APPLICATION NO.	FILING DATE	FIRST NAMED INVENTOR	ATTORNEY DOCKET NO.	CONFIRMATION NO.
10/603,487	06/25/2003	Jaime Garcia	PTG 02-7-2	3134

Office Action Summary

DETAILED ACTION

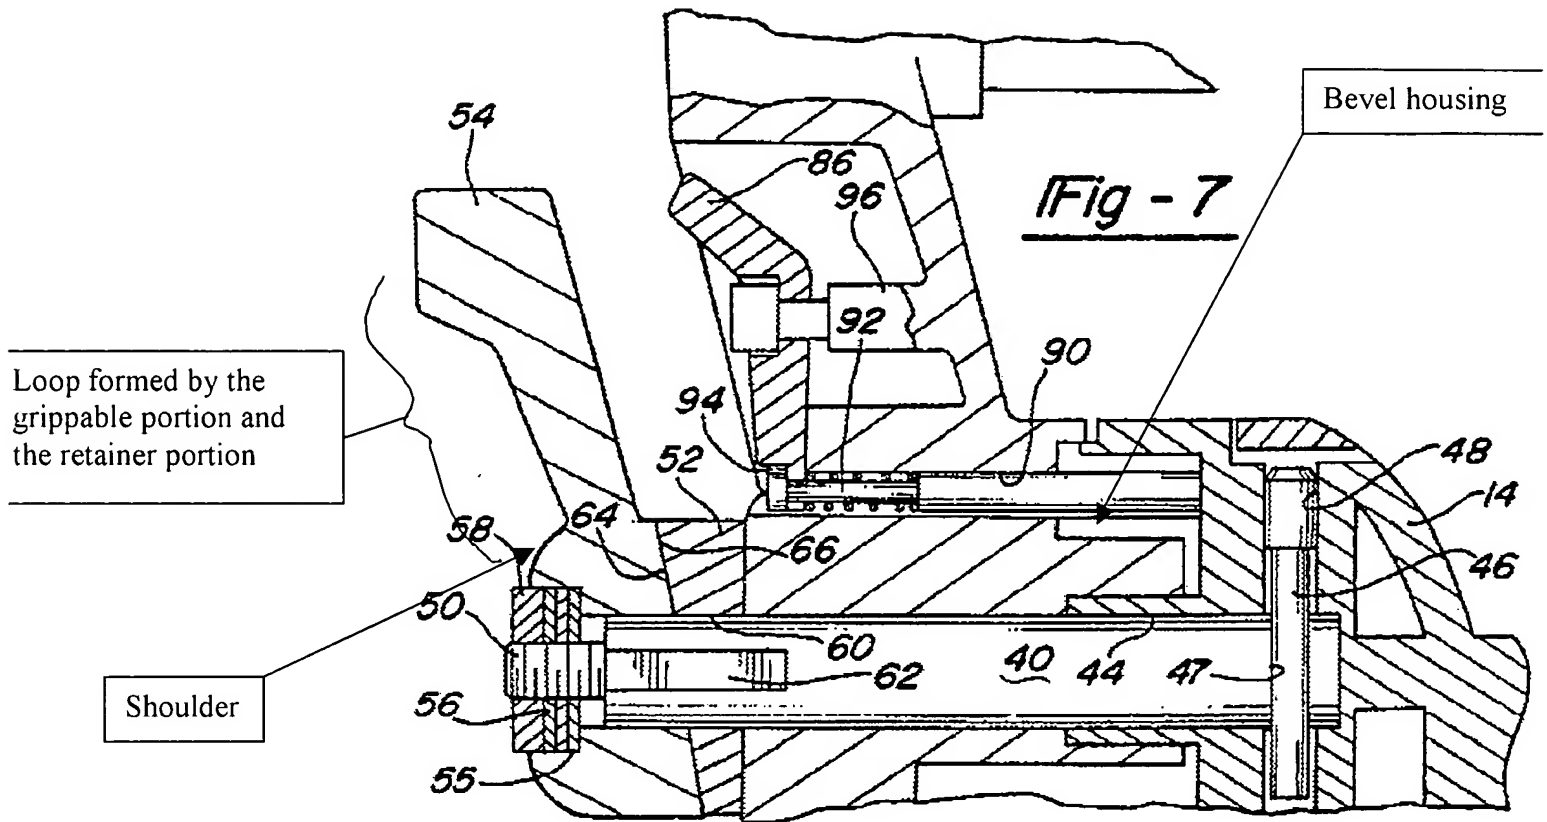
Regarding claims 35 and 36, Brunson teaches a bevel lock for a miter saw comprising a grippable portion 54 having a cam surface 66, a bevel housing and a generally cylindrical shaft 40. See Figs. 4, 5 and 7.

Regarding claim 37, a shoulder of the retaining portion is best seen in Fig. 7.

Regarding claim 38, as best understood by the Examiner, pin 84 is a part of the retaining portion and it passes through a housing 90. See Fig. 5 and 7.

Regarding claim 39, a loop formed by the grippable portion and the retaining portion is best seen in Fig. 7.

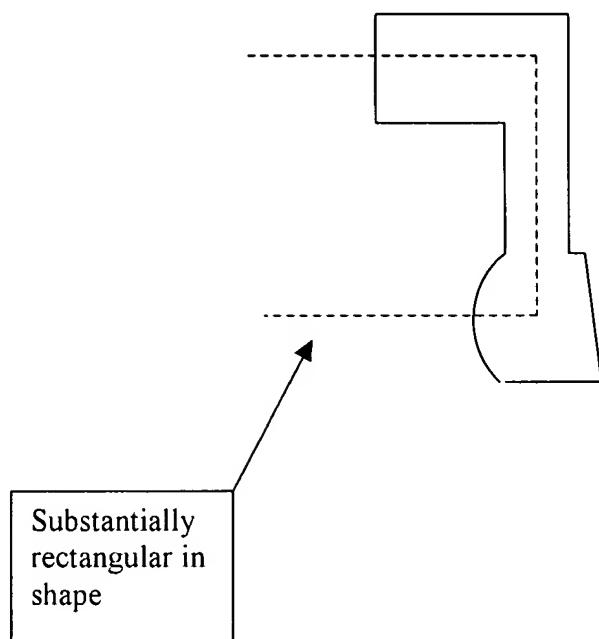
Brunson teaches the invention substantially as claimed except for the loop being substantially rectangular in shape. Changing a shape of a part without destroying its function is routine skill in the art. Therefore, it would have been obvious to one skilled in the art to make the grippable portion and the retainer portion in substantially rectangular shape for aesthetic purpose.
